3.4 Instrumentation and Control

The information in this section of the reference ABWR DCD, including all subsections, tables, and figures, is incorporated by reference with the following departure.

STD DEP T1 3.4-1 (Figure 3.4a, Figure 3.4b, Figure 3.4c)

Figure 3.4a Safety System Logic and Control (SSLC) Control Interface Diagram

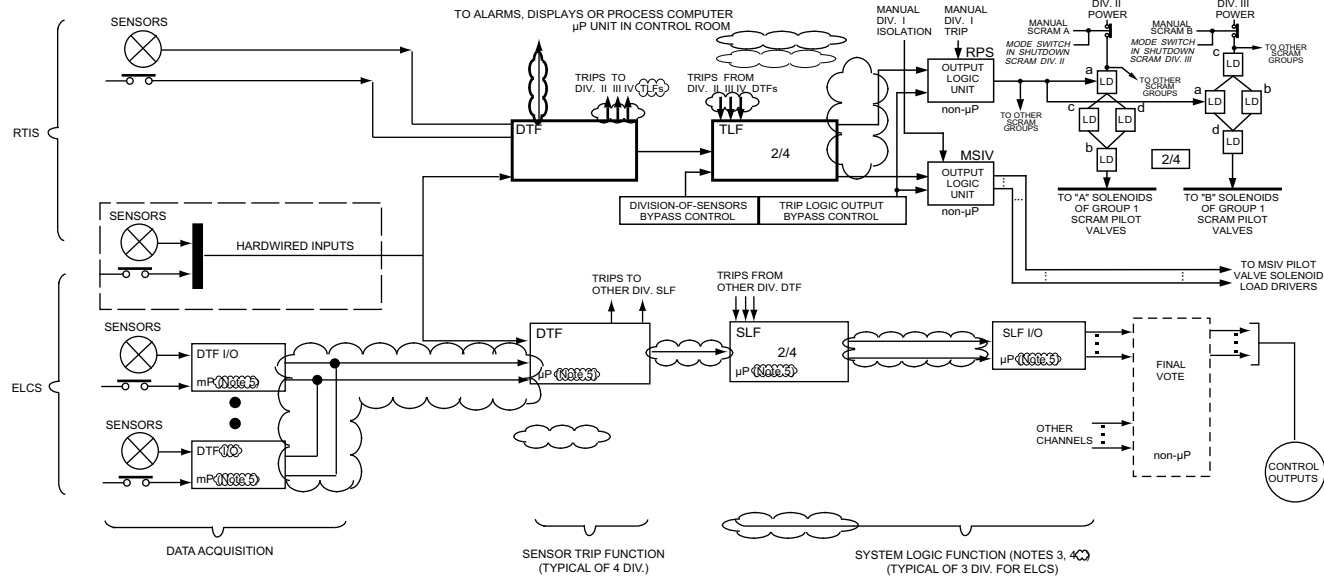
safety-related portions of the Neutron Monitoring System (NMS), the Containment Atmospheric Monitoring System (CAMS) and the radiation monitoring systems. The relationship between SSLC and systems for plant protection is shown in Figure 3.4a.

- ALL SOLID LINE CONNECTIONS NOT EXPLICITLY IDENTIFIED CAN BE EITHER HARD WIRED OR FIBER OPTIC.
- SAFETY SYSTEM LOGIC FUNCTION (SLF)** FOR ECCS FUNCTIONS IS IMPLEMENTED WITH REDUNDANT CHANNELS WITH A MINIMUM 2/2 VOTE OF THE OUTPUT SIGNALS TO PREVENT INADVERTENT COOLANT INJECTION OR DEPRESSURIZATION DUE TO SINGLE SLF ELECTRONICS FAILURE. THE OUTPUT VOTE MAY BE ACCOMPLISHED EITHER BY DIRECT VOTE OF SLF OUTPUT SIGNALS OR BY A SYSTEM VOTE WHERE BOTH VALVE AND PUMP ACTUATION IS REQUIRED TO INITIATE SYSTEM ACTION. BYPASS OF A FAILED SLF CHANNEL MAY BE PROVIDED AS LONG AS THE REMAINING OPERATIONAL CHANNELS PROVIDE A MINIMUM OF TWO SLF CHANNELS FOR ECCS FUNCTIONS.

- SAFETY SYSTEM LOGIC FUNCTION (SLF)** FOR SOME ISOLATION AND SUPPORTING ESF FUNCTIONS MAY BE IMPLEMENTED WITH REDUNDANT CHANNELS WITH A NORMAL MINIMUM 2/2 VOTE OF THE OUTPUT SIGNALS WHERE INADVERTENT ACTUATION OF THE FUNCTION MIGHT REQUIRE UNREASONABLY SHORT REPAIR TIMES TO ELIMINATE OPERATIONAL IMPACT. FOR THESE FUNCTIONS, OPERATIONAL CONTROLLED BYPASS TO ALLOW OPERATION WITH A FINAL 1/1 VOTE IS PERMITTED.

- EACH FUNCTION MAY BE ACCOMPLISHED BY MULTIPLE PROCESSORS TO MINIMIZE THE HARDWARE AND SOFTWARE COMPLEXITY OR OPERATIONAL IMPACT OF HARDWARE FAILURES, PROVIDED THE MINIMUM REDUNDANCY OF NOTES 3 AND 4 IS MAINTAINED.

Figure 3.4b Safety System Logic & Control Block Diagram

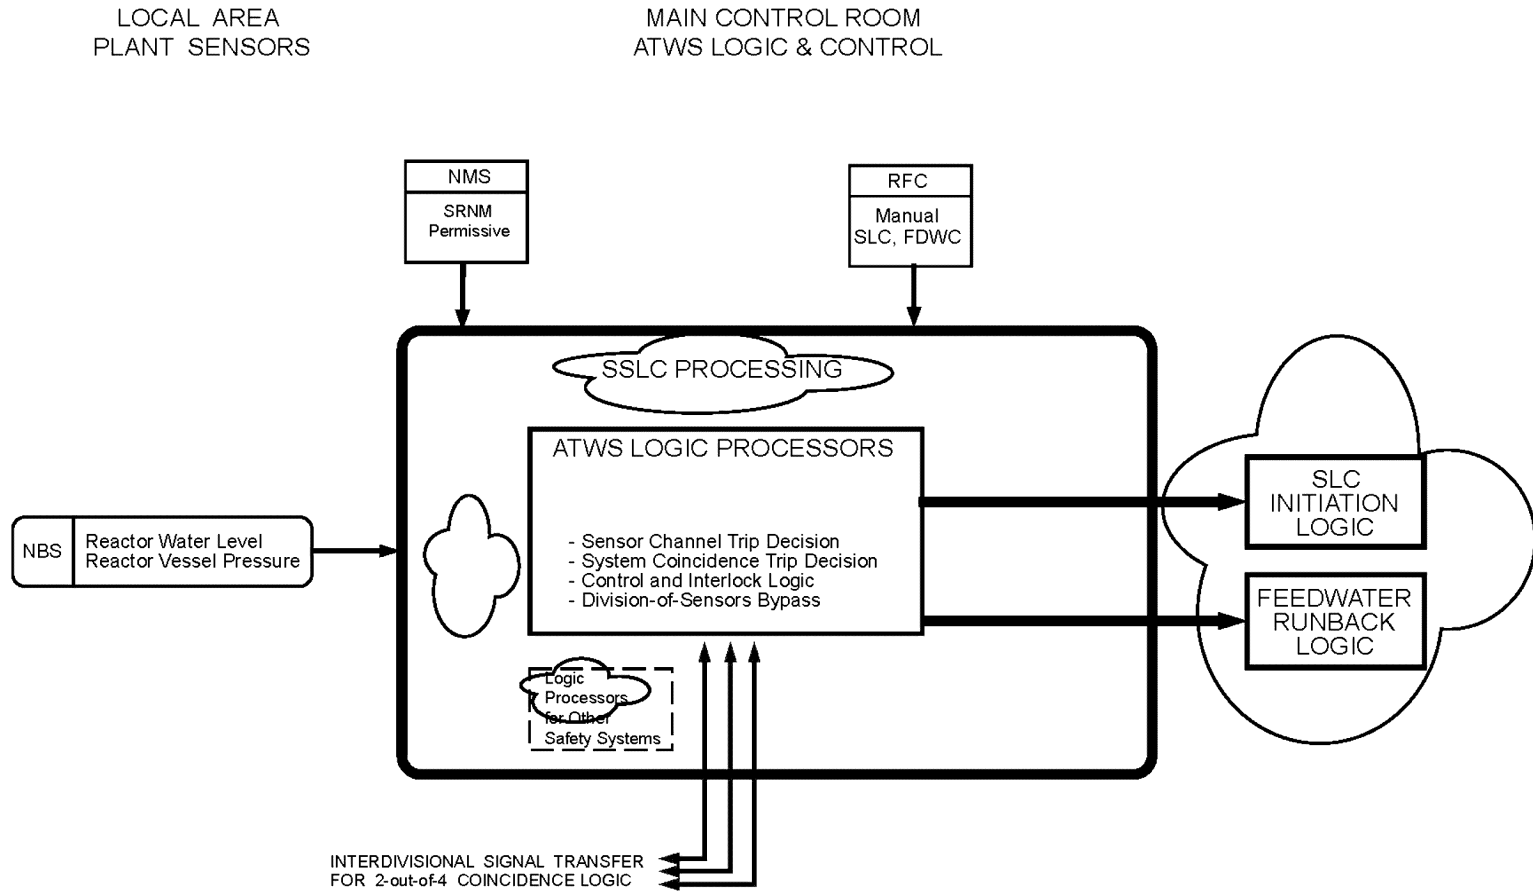
~~The basic hardware functional configuration for one division of SSLC is shown in Figure 3.4b. Each division runs independently (i.e., asynchronously) with respect to the other divisions. The following steps describe the processing sequence and associated function descriptions for incoming sensor signals and outgoing control signals. These steps are performed simultaneously and independently in each of the four divisions:~~
